Project 717

MFN 03-099
September 16, 2003

Subject: **Response to Request for Additional Information (RAI) numbers (70, 71, 82, 86, 87, 316, and 318) for ESBWR Pre-application Review.**

**Response to NRC RAI numbers (70, 71, 82, 86, 87, and 316), and
additional information provided in response to RAI 318**

These correlation are compared in Figure 316-1 for $Pr = 1.0$.

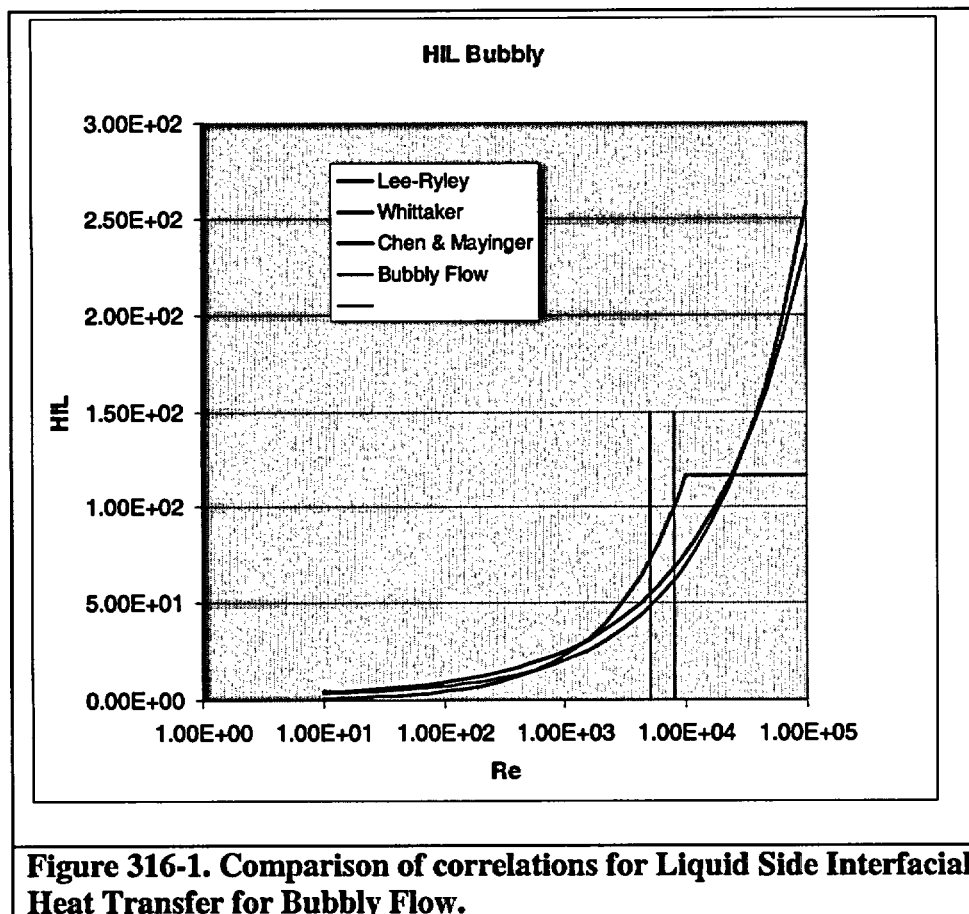
Q316.1. It is our understanding that the liquid side interfacial heat transfer coefficient is obtained from a correlation developed for heat transfer over evaporating drops. Provide a description of the physical process being modeled and justify its use for this situation.

R316.1. TRACG uses the Lee-Ryley correlation for the vapor side interfacial heat transfer for droplet flow.

This correlation was developed from data for evaporating droplets. Since the flow around a droplet is very similar to the flow around a vapor bubble for bubbly flow, it is assumed that the same correlation is applicable to the liquid side interfacial heat transfer for bubbly flow. For liquid, the Prandlt number dependence was dropped, since $Pr \approx 1$ for water.

TRAC-M (NUREG/CR-6724) uses a combination of the Whittaker correlation for low Reynolds numbers and the Chen & Mayinger correlation for high Reynolds numbers to calculate the liquid side interfacial heat transfer for bubbly flow:

For bubbly flow the Reynolds number for the bubbles are typically in the range of 5000 to 8000. For this range the Whittaker correlation is 10% lower than the Lee-Ryley correlation, and the Chen & Mayinger correlation is approximately 40% higher than the Lee-Ryley correlation. These differences are compatible with the uncertainty range for the correlations.

The good comparison to void fraction data and plant transient data as demonstrated in the TRACG Qualification (NEDE-32177P) justifies the application of the Lee-Ryley for the interfacial heat transfer. In the TRACG application (NEDE-32178P) a factor of 2 (-50%, +100%) uncertainty is assumed for liquid side interfacial heat transfer. This uncertainty more than covers the difference between the above correlations.
